Final Versatile Test Reactor Environmental Impact Statement

Comment Response Document

Figure 1. Ratio of the revised Federal Guidance Report (FGR) 13 thyroid dose conversion factors (DCFs) to the original Department of Energy (HUDUFACT.dat) thyroid DCF for radionuclides having the largest increases. (PNNL-22827)

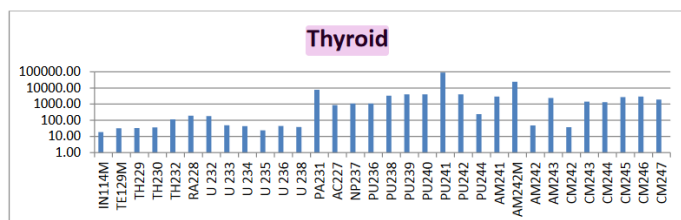
A 2013 Pacific Northwest National Laboratory (PNNL) report incorporating Federal Guidance Report 13 tabulated whole body and organ specific dose conversion factors for an average half-male and half-female at various ages.¹⁴ The 2013 PNNL report is to be used for calculating radiation dose but not the risk of higher radiation risks recognized in the EPA's 1999 Federal Guidance Report 13. Buried near the end of the PNNL report is a chart of how wildly increased the thyroid cancer incidence was for various radionuclides, by a factor of 10, of 100, of 1000, of 10,000 and of 100,000! See Figure 1.

The radionuclides in Figure 1 include thorium, uranium and uranium decay progeny, plutonium, curium and americium. The thyroid cancer incidence rate increases for plutonium-238, plutonium-239, plutonium-240, plutonium-241 and americium-241 is over 1000.

**23-76
cont'd**

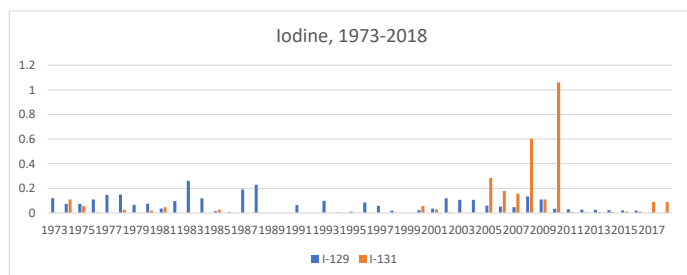
Then let's take a look at the iodine-129 and iodine-131 releases between 1973 and 2017, in curies. The State of Idaho DEQ went from displaying all of their environmental monitoring reports to displaying ten years of the reports, to now displaying only six years of annual reports and only 4 years of quarterly data reports from 2013 to 2018. **Again, here you can see why the Idaho DEQ didn't want to display INL monitoring data before 2013.**

23-73 Environmental monitoring is performed at all DOE sites including INL. The monitoring programs record and document the impacts of activities at each site. Information about monitoring may be found in the Annual Site Environmental Reports (ASER) for each location via the following link: <https://www.energy.gov/ehss/downloads/asere-links>. Information presented in the ASERs complies with DOE Order 231.1B, "Environment, Safety and Health Reporting," and the INL Site Environmental Monitoring Plan is in compliance with DOE Order DOE Order 458.1, "Radiation Protection of the Public and the Environment." This VTR EIS presents the most recent information available on the current environment at the INL Site. The concerns expressed by the commenter regarding the current monitoring program and the determination of the source of existing contamination (e.g., strontium, cesium, and other radionuclides in the marmot tissue samples) at the INL Site are not within the scope of this EIS.

Photo 1. A photo from Artist-in-Residence Matt Dieterich of the celebrated stargazing potential at Craters of the Moon.

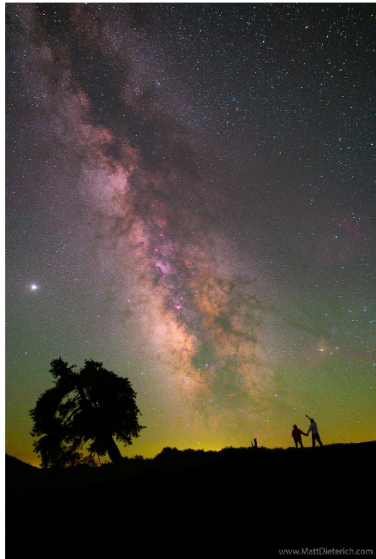
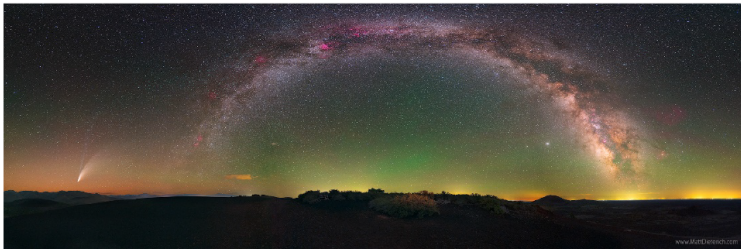
left in the lower 48 with exceptional darkness with the majestic sweep of the Milky Way regularly evident over the sere landscape. The photos below illustrate the beauty and power of the dark skies above Craters of the Moon.

Figure 2. A calibrated hemispheric panorama taken from Inferno Cone mapping all natural and anthropogenic light sources.

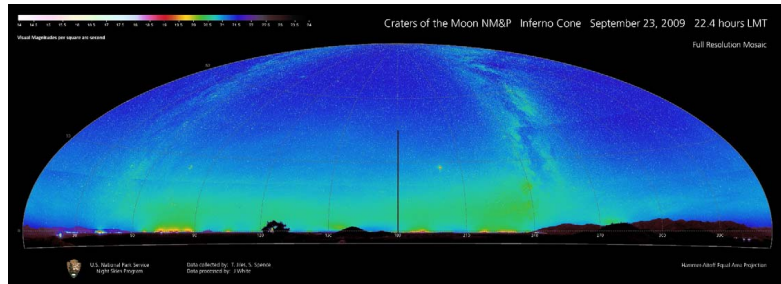
We strongly encourage night sky impacts to Craters of the Moon to be included in Chapter 5: Cumulative Impacts in the final EIS. Calibrated hemispheric light pollution measurements taken from near Craters of the Moon headquarters detail the exact location and impact of anthropogenic lights as observed from the park (Figure 1). Data from the National Park Service Natural Sounds and Night Skies Division (NSNSD) show that, overall, Craters of the Moon has excellent night sky conditions. When considering the entire hemisphere as observed from the park, average sky brightness is just 19.5% brighter than natural conditions. Overhead, sky brightness is truly natural, but conditions degrade closer to the horizon.

Figure 3. A regional map of anthropogenic light ratio (ALR) derived from visible infrared imaging radiometer suite (VIIRS) satellite data illustrating the spatial distribution and intensity of light pollution, expressed in a ratio over natural conditions, around Craters of the Moon.

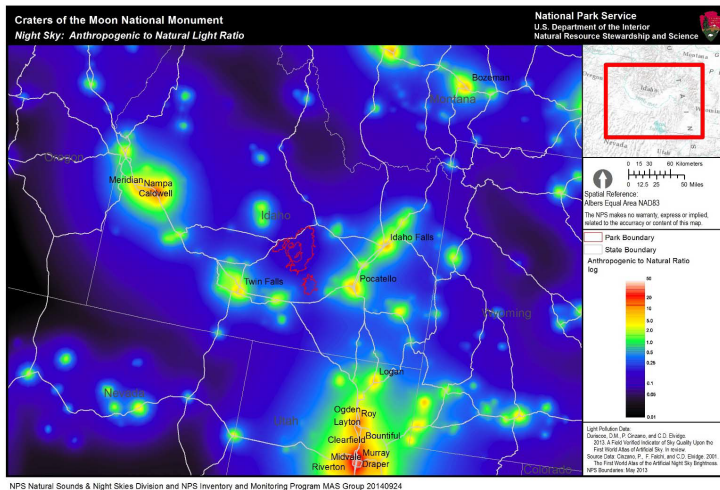
Calibrated satellite data can also be used to map the extent of skyglow at a landscape scale. Using data from the New World Atlas of Light Pollution, we can measure the all-sky light pollution ratio (ratio of artificial to natural light for the whole hemisphere for one observation point). When assessing regional light pollution around Craters of the Moon, the contribution of light from INL facilities is readily apparent (Figure 3). The all-sky light pollution ratio over INL

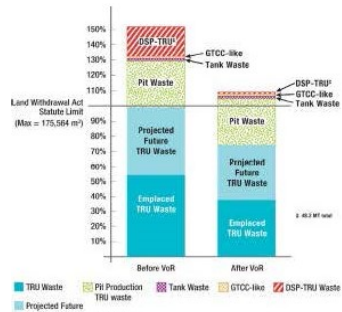
Because of not using permitted capacity, WIPP also does not have room for all of the legacy TRU waste that was supposed to go to WIPP. The NAS Report Figure S-5 shows that the legacy TRU amounts to about the legal capacity limit before the Volume of Record (VOR).

Given the unused capacity in panels 1-7, there is not room for all of the legacy TRU waste. Thus, to allocate any space for the 34 MT of surplus plutonium or VTR waste would mean that very substantial amounts of legacy defense TRU waste would remain at the storage sites. The WIPP Permit currently states that disposal ends in 2024,¹⁰ while the VTR is to operate for 60 years, much beyond the WIPP lifetime. In its NEPA documents, NE must recognize those facts.
